51" VORTEX FANS

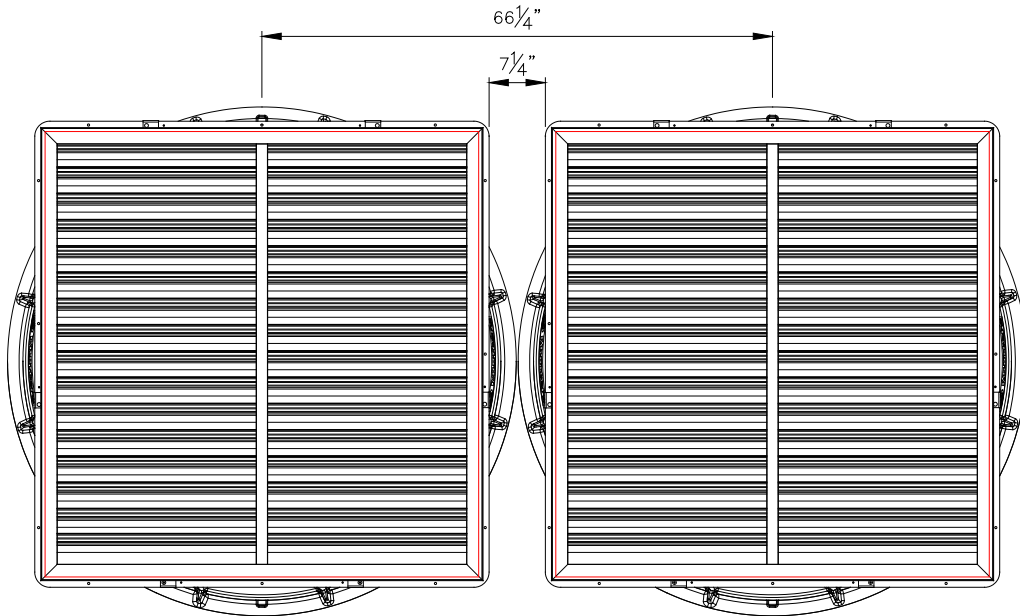
If your building has Vortex 51" or Vortex 55" fans and you are interested in installing the new One Piece Polycone (51RC or 55RC), the first step is to measure the distance between the flanges of each fan. If there is  $7\frac{1}{4}$ " or more between the flanges, you can install the polycones on the fans and have proper clearance. If the flanges are closer than  $7\frac{1}{4}$ ", contact your Munters Regional Representative or the Munters office to discuss options.

For new installations of the Vortex 51" or Vortex 55" fan with the new One Piece Polycone (51RC or 55RC), the recommended fan spacing is as follows: For the 51" fan use 68" O.C. and for the 55" fan use 72" O.C. The minimum spacing for the 51" fan is 66" O.C. and the minimum spacing for the 55" fan is 70" O.C. For spacing closer than the minimum, contact your Munters Regional Representative or the Munters office to discuss options.
